Contract 009896 Provisions and Plans

SR 534
UNNAMED TRIBUTARY TO CARPENTER CREEK
FISH PASSAGE

Addendum No. 2

The Special Provisions, Plans, and Proposal for this project are amended as follows:

PAVING PLAN

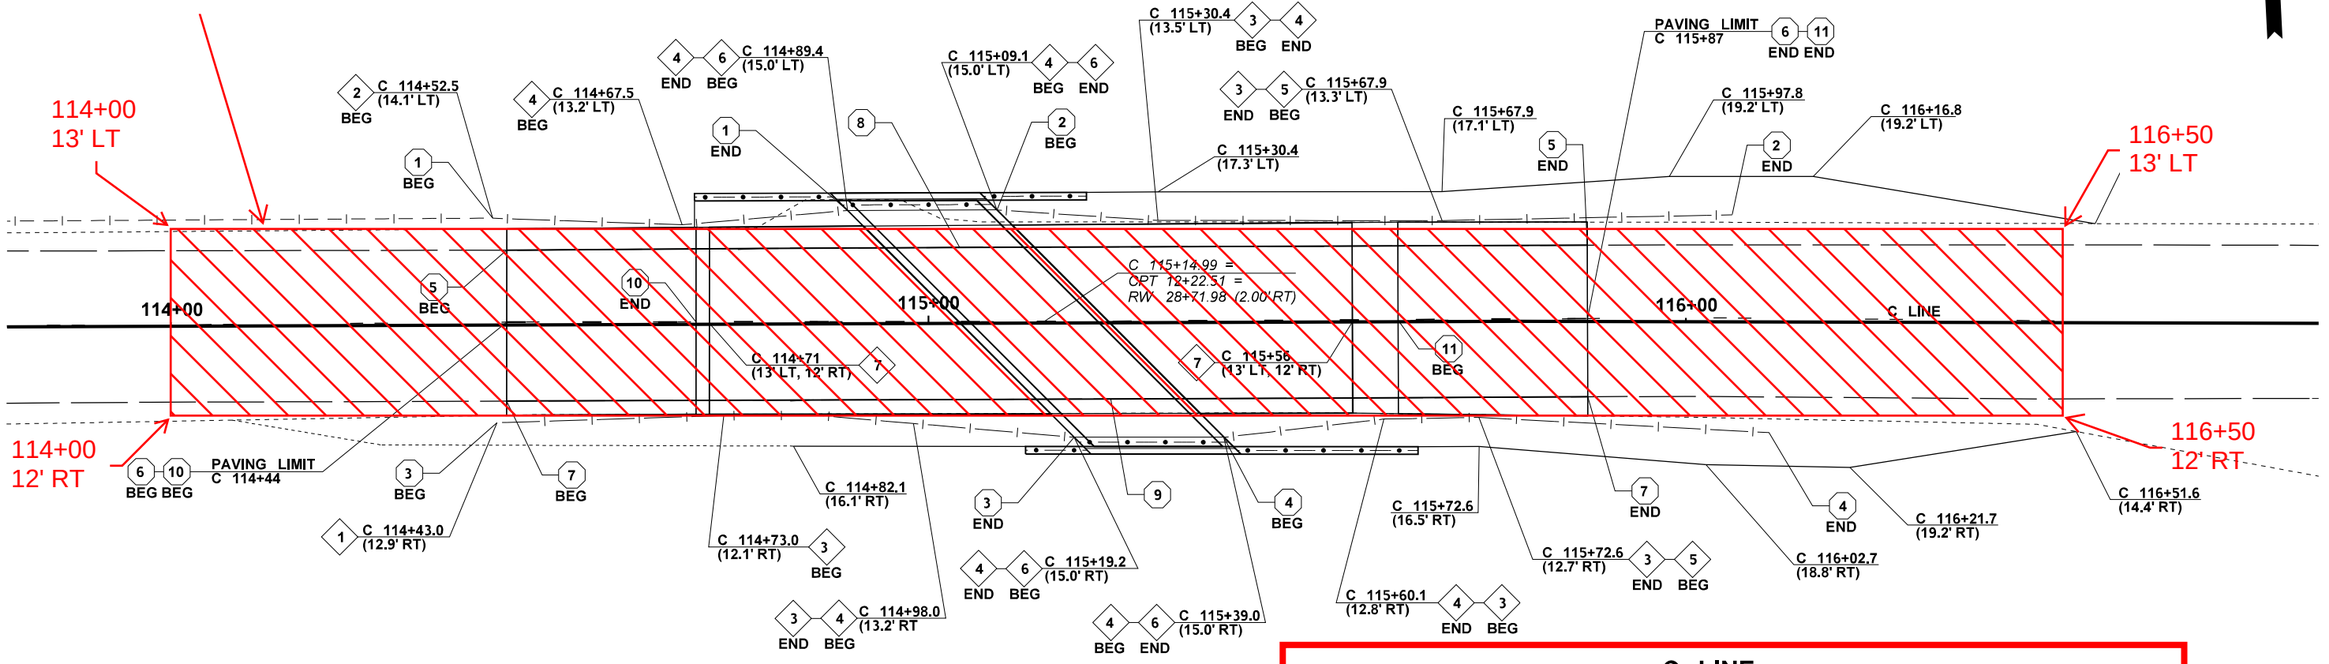
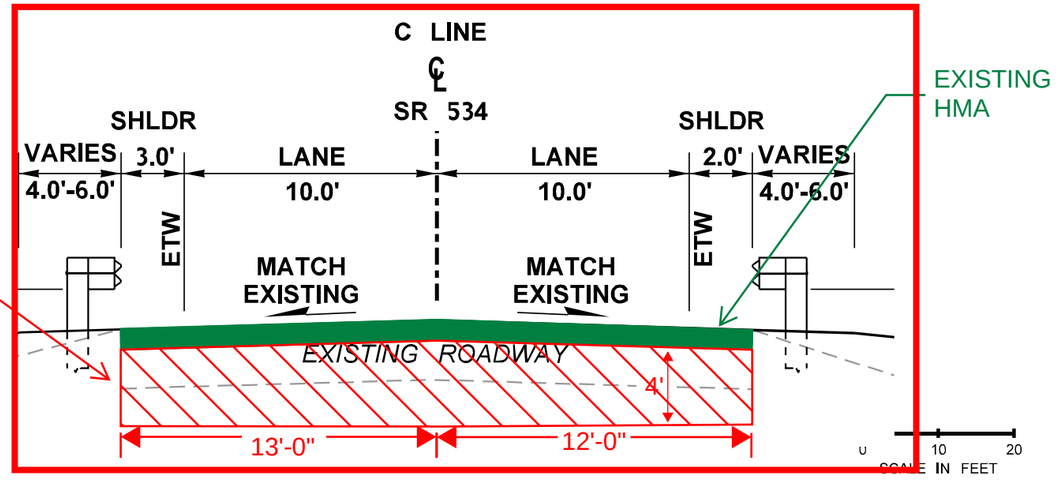
Contaminated soil has been identified under SR 534 within the work zone limits. WSDOT has performed testing and received the results in the table below. Plan pages are attached to this Addendum #2 to provide the extent of the contamination. Material will need to be disposed of per WA State Dept of Ecology or Snohomish Health District standards.

AREA WITH CONTAMINATED MATERIAL

STA 114+00 TO 116+50

AREA WITH CONTAMINATED MATERIAL

One (1) working day and an additional 24 hours in the full SR 534 closure is granted to handle this work.

Bid Item 79 to be added as one (1) Lump Sum to include all traffic control for the additional closure time and hauling and disposal of the material.
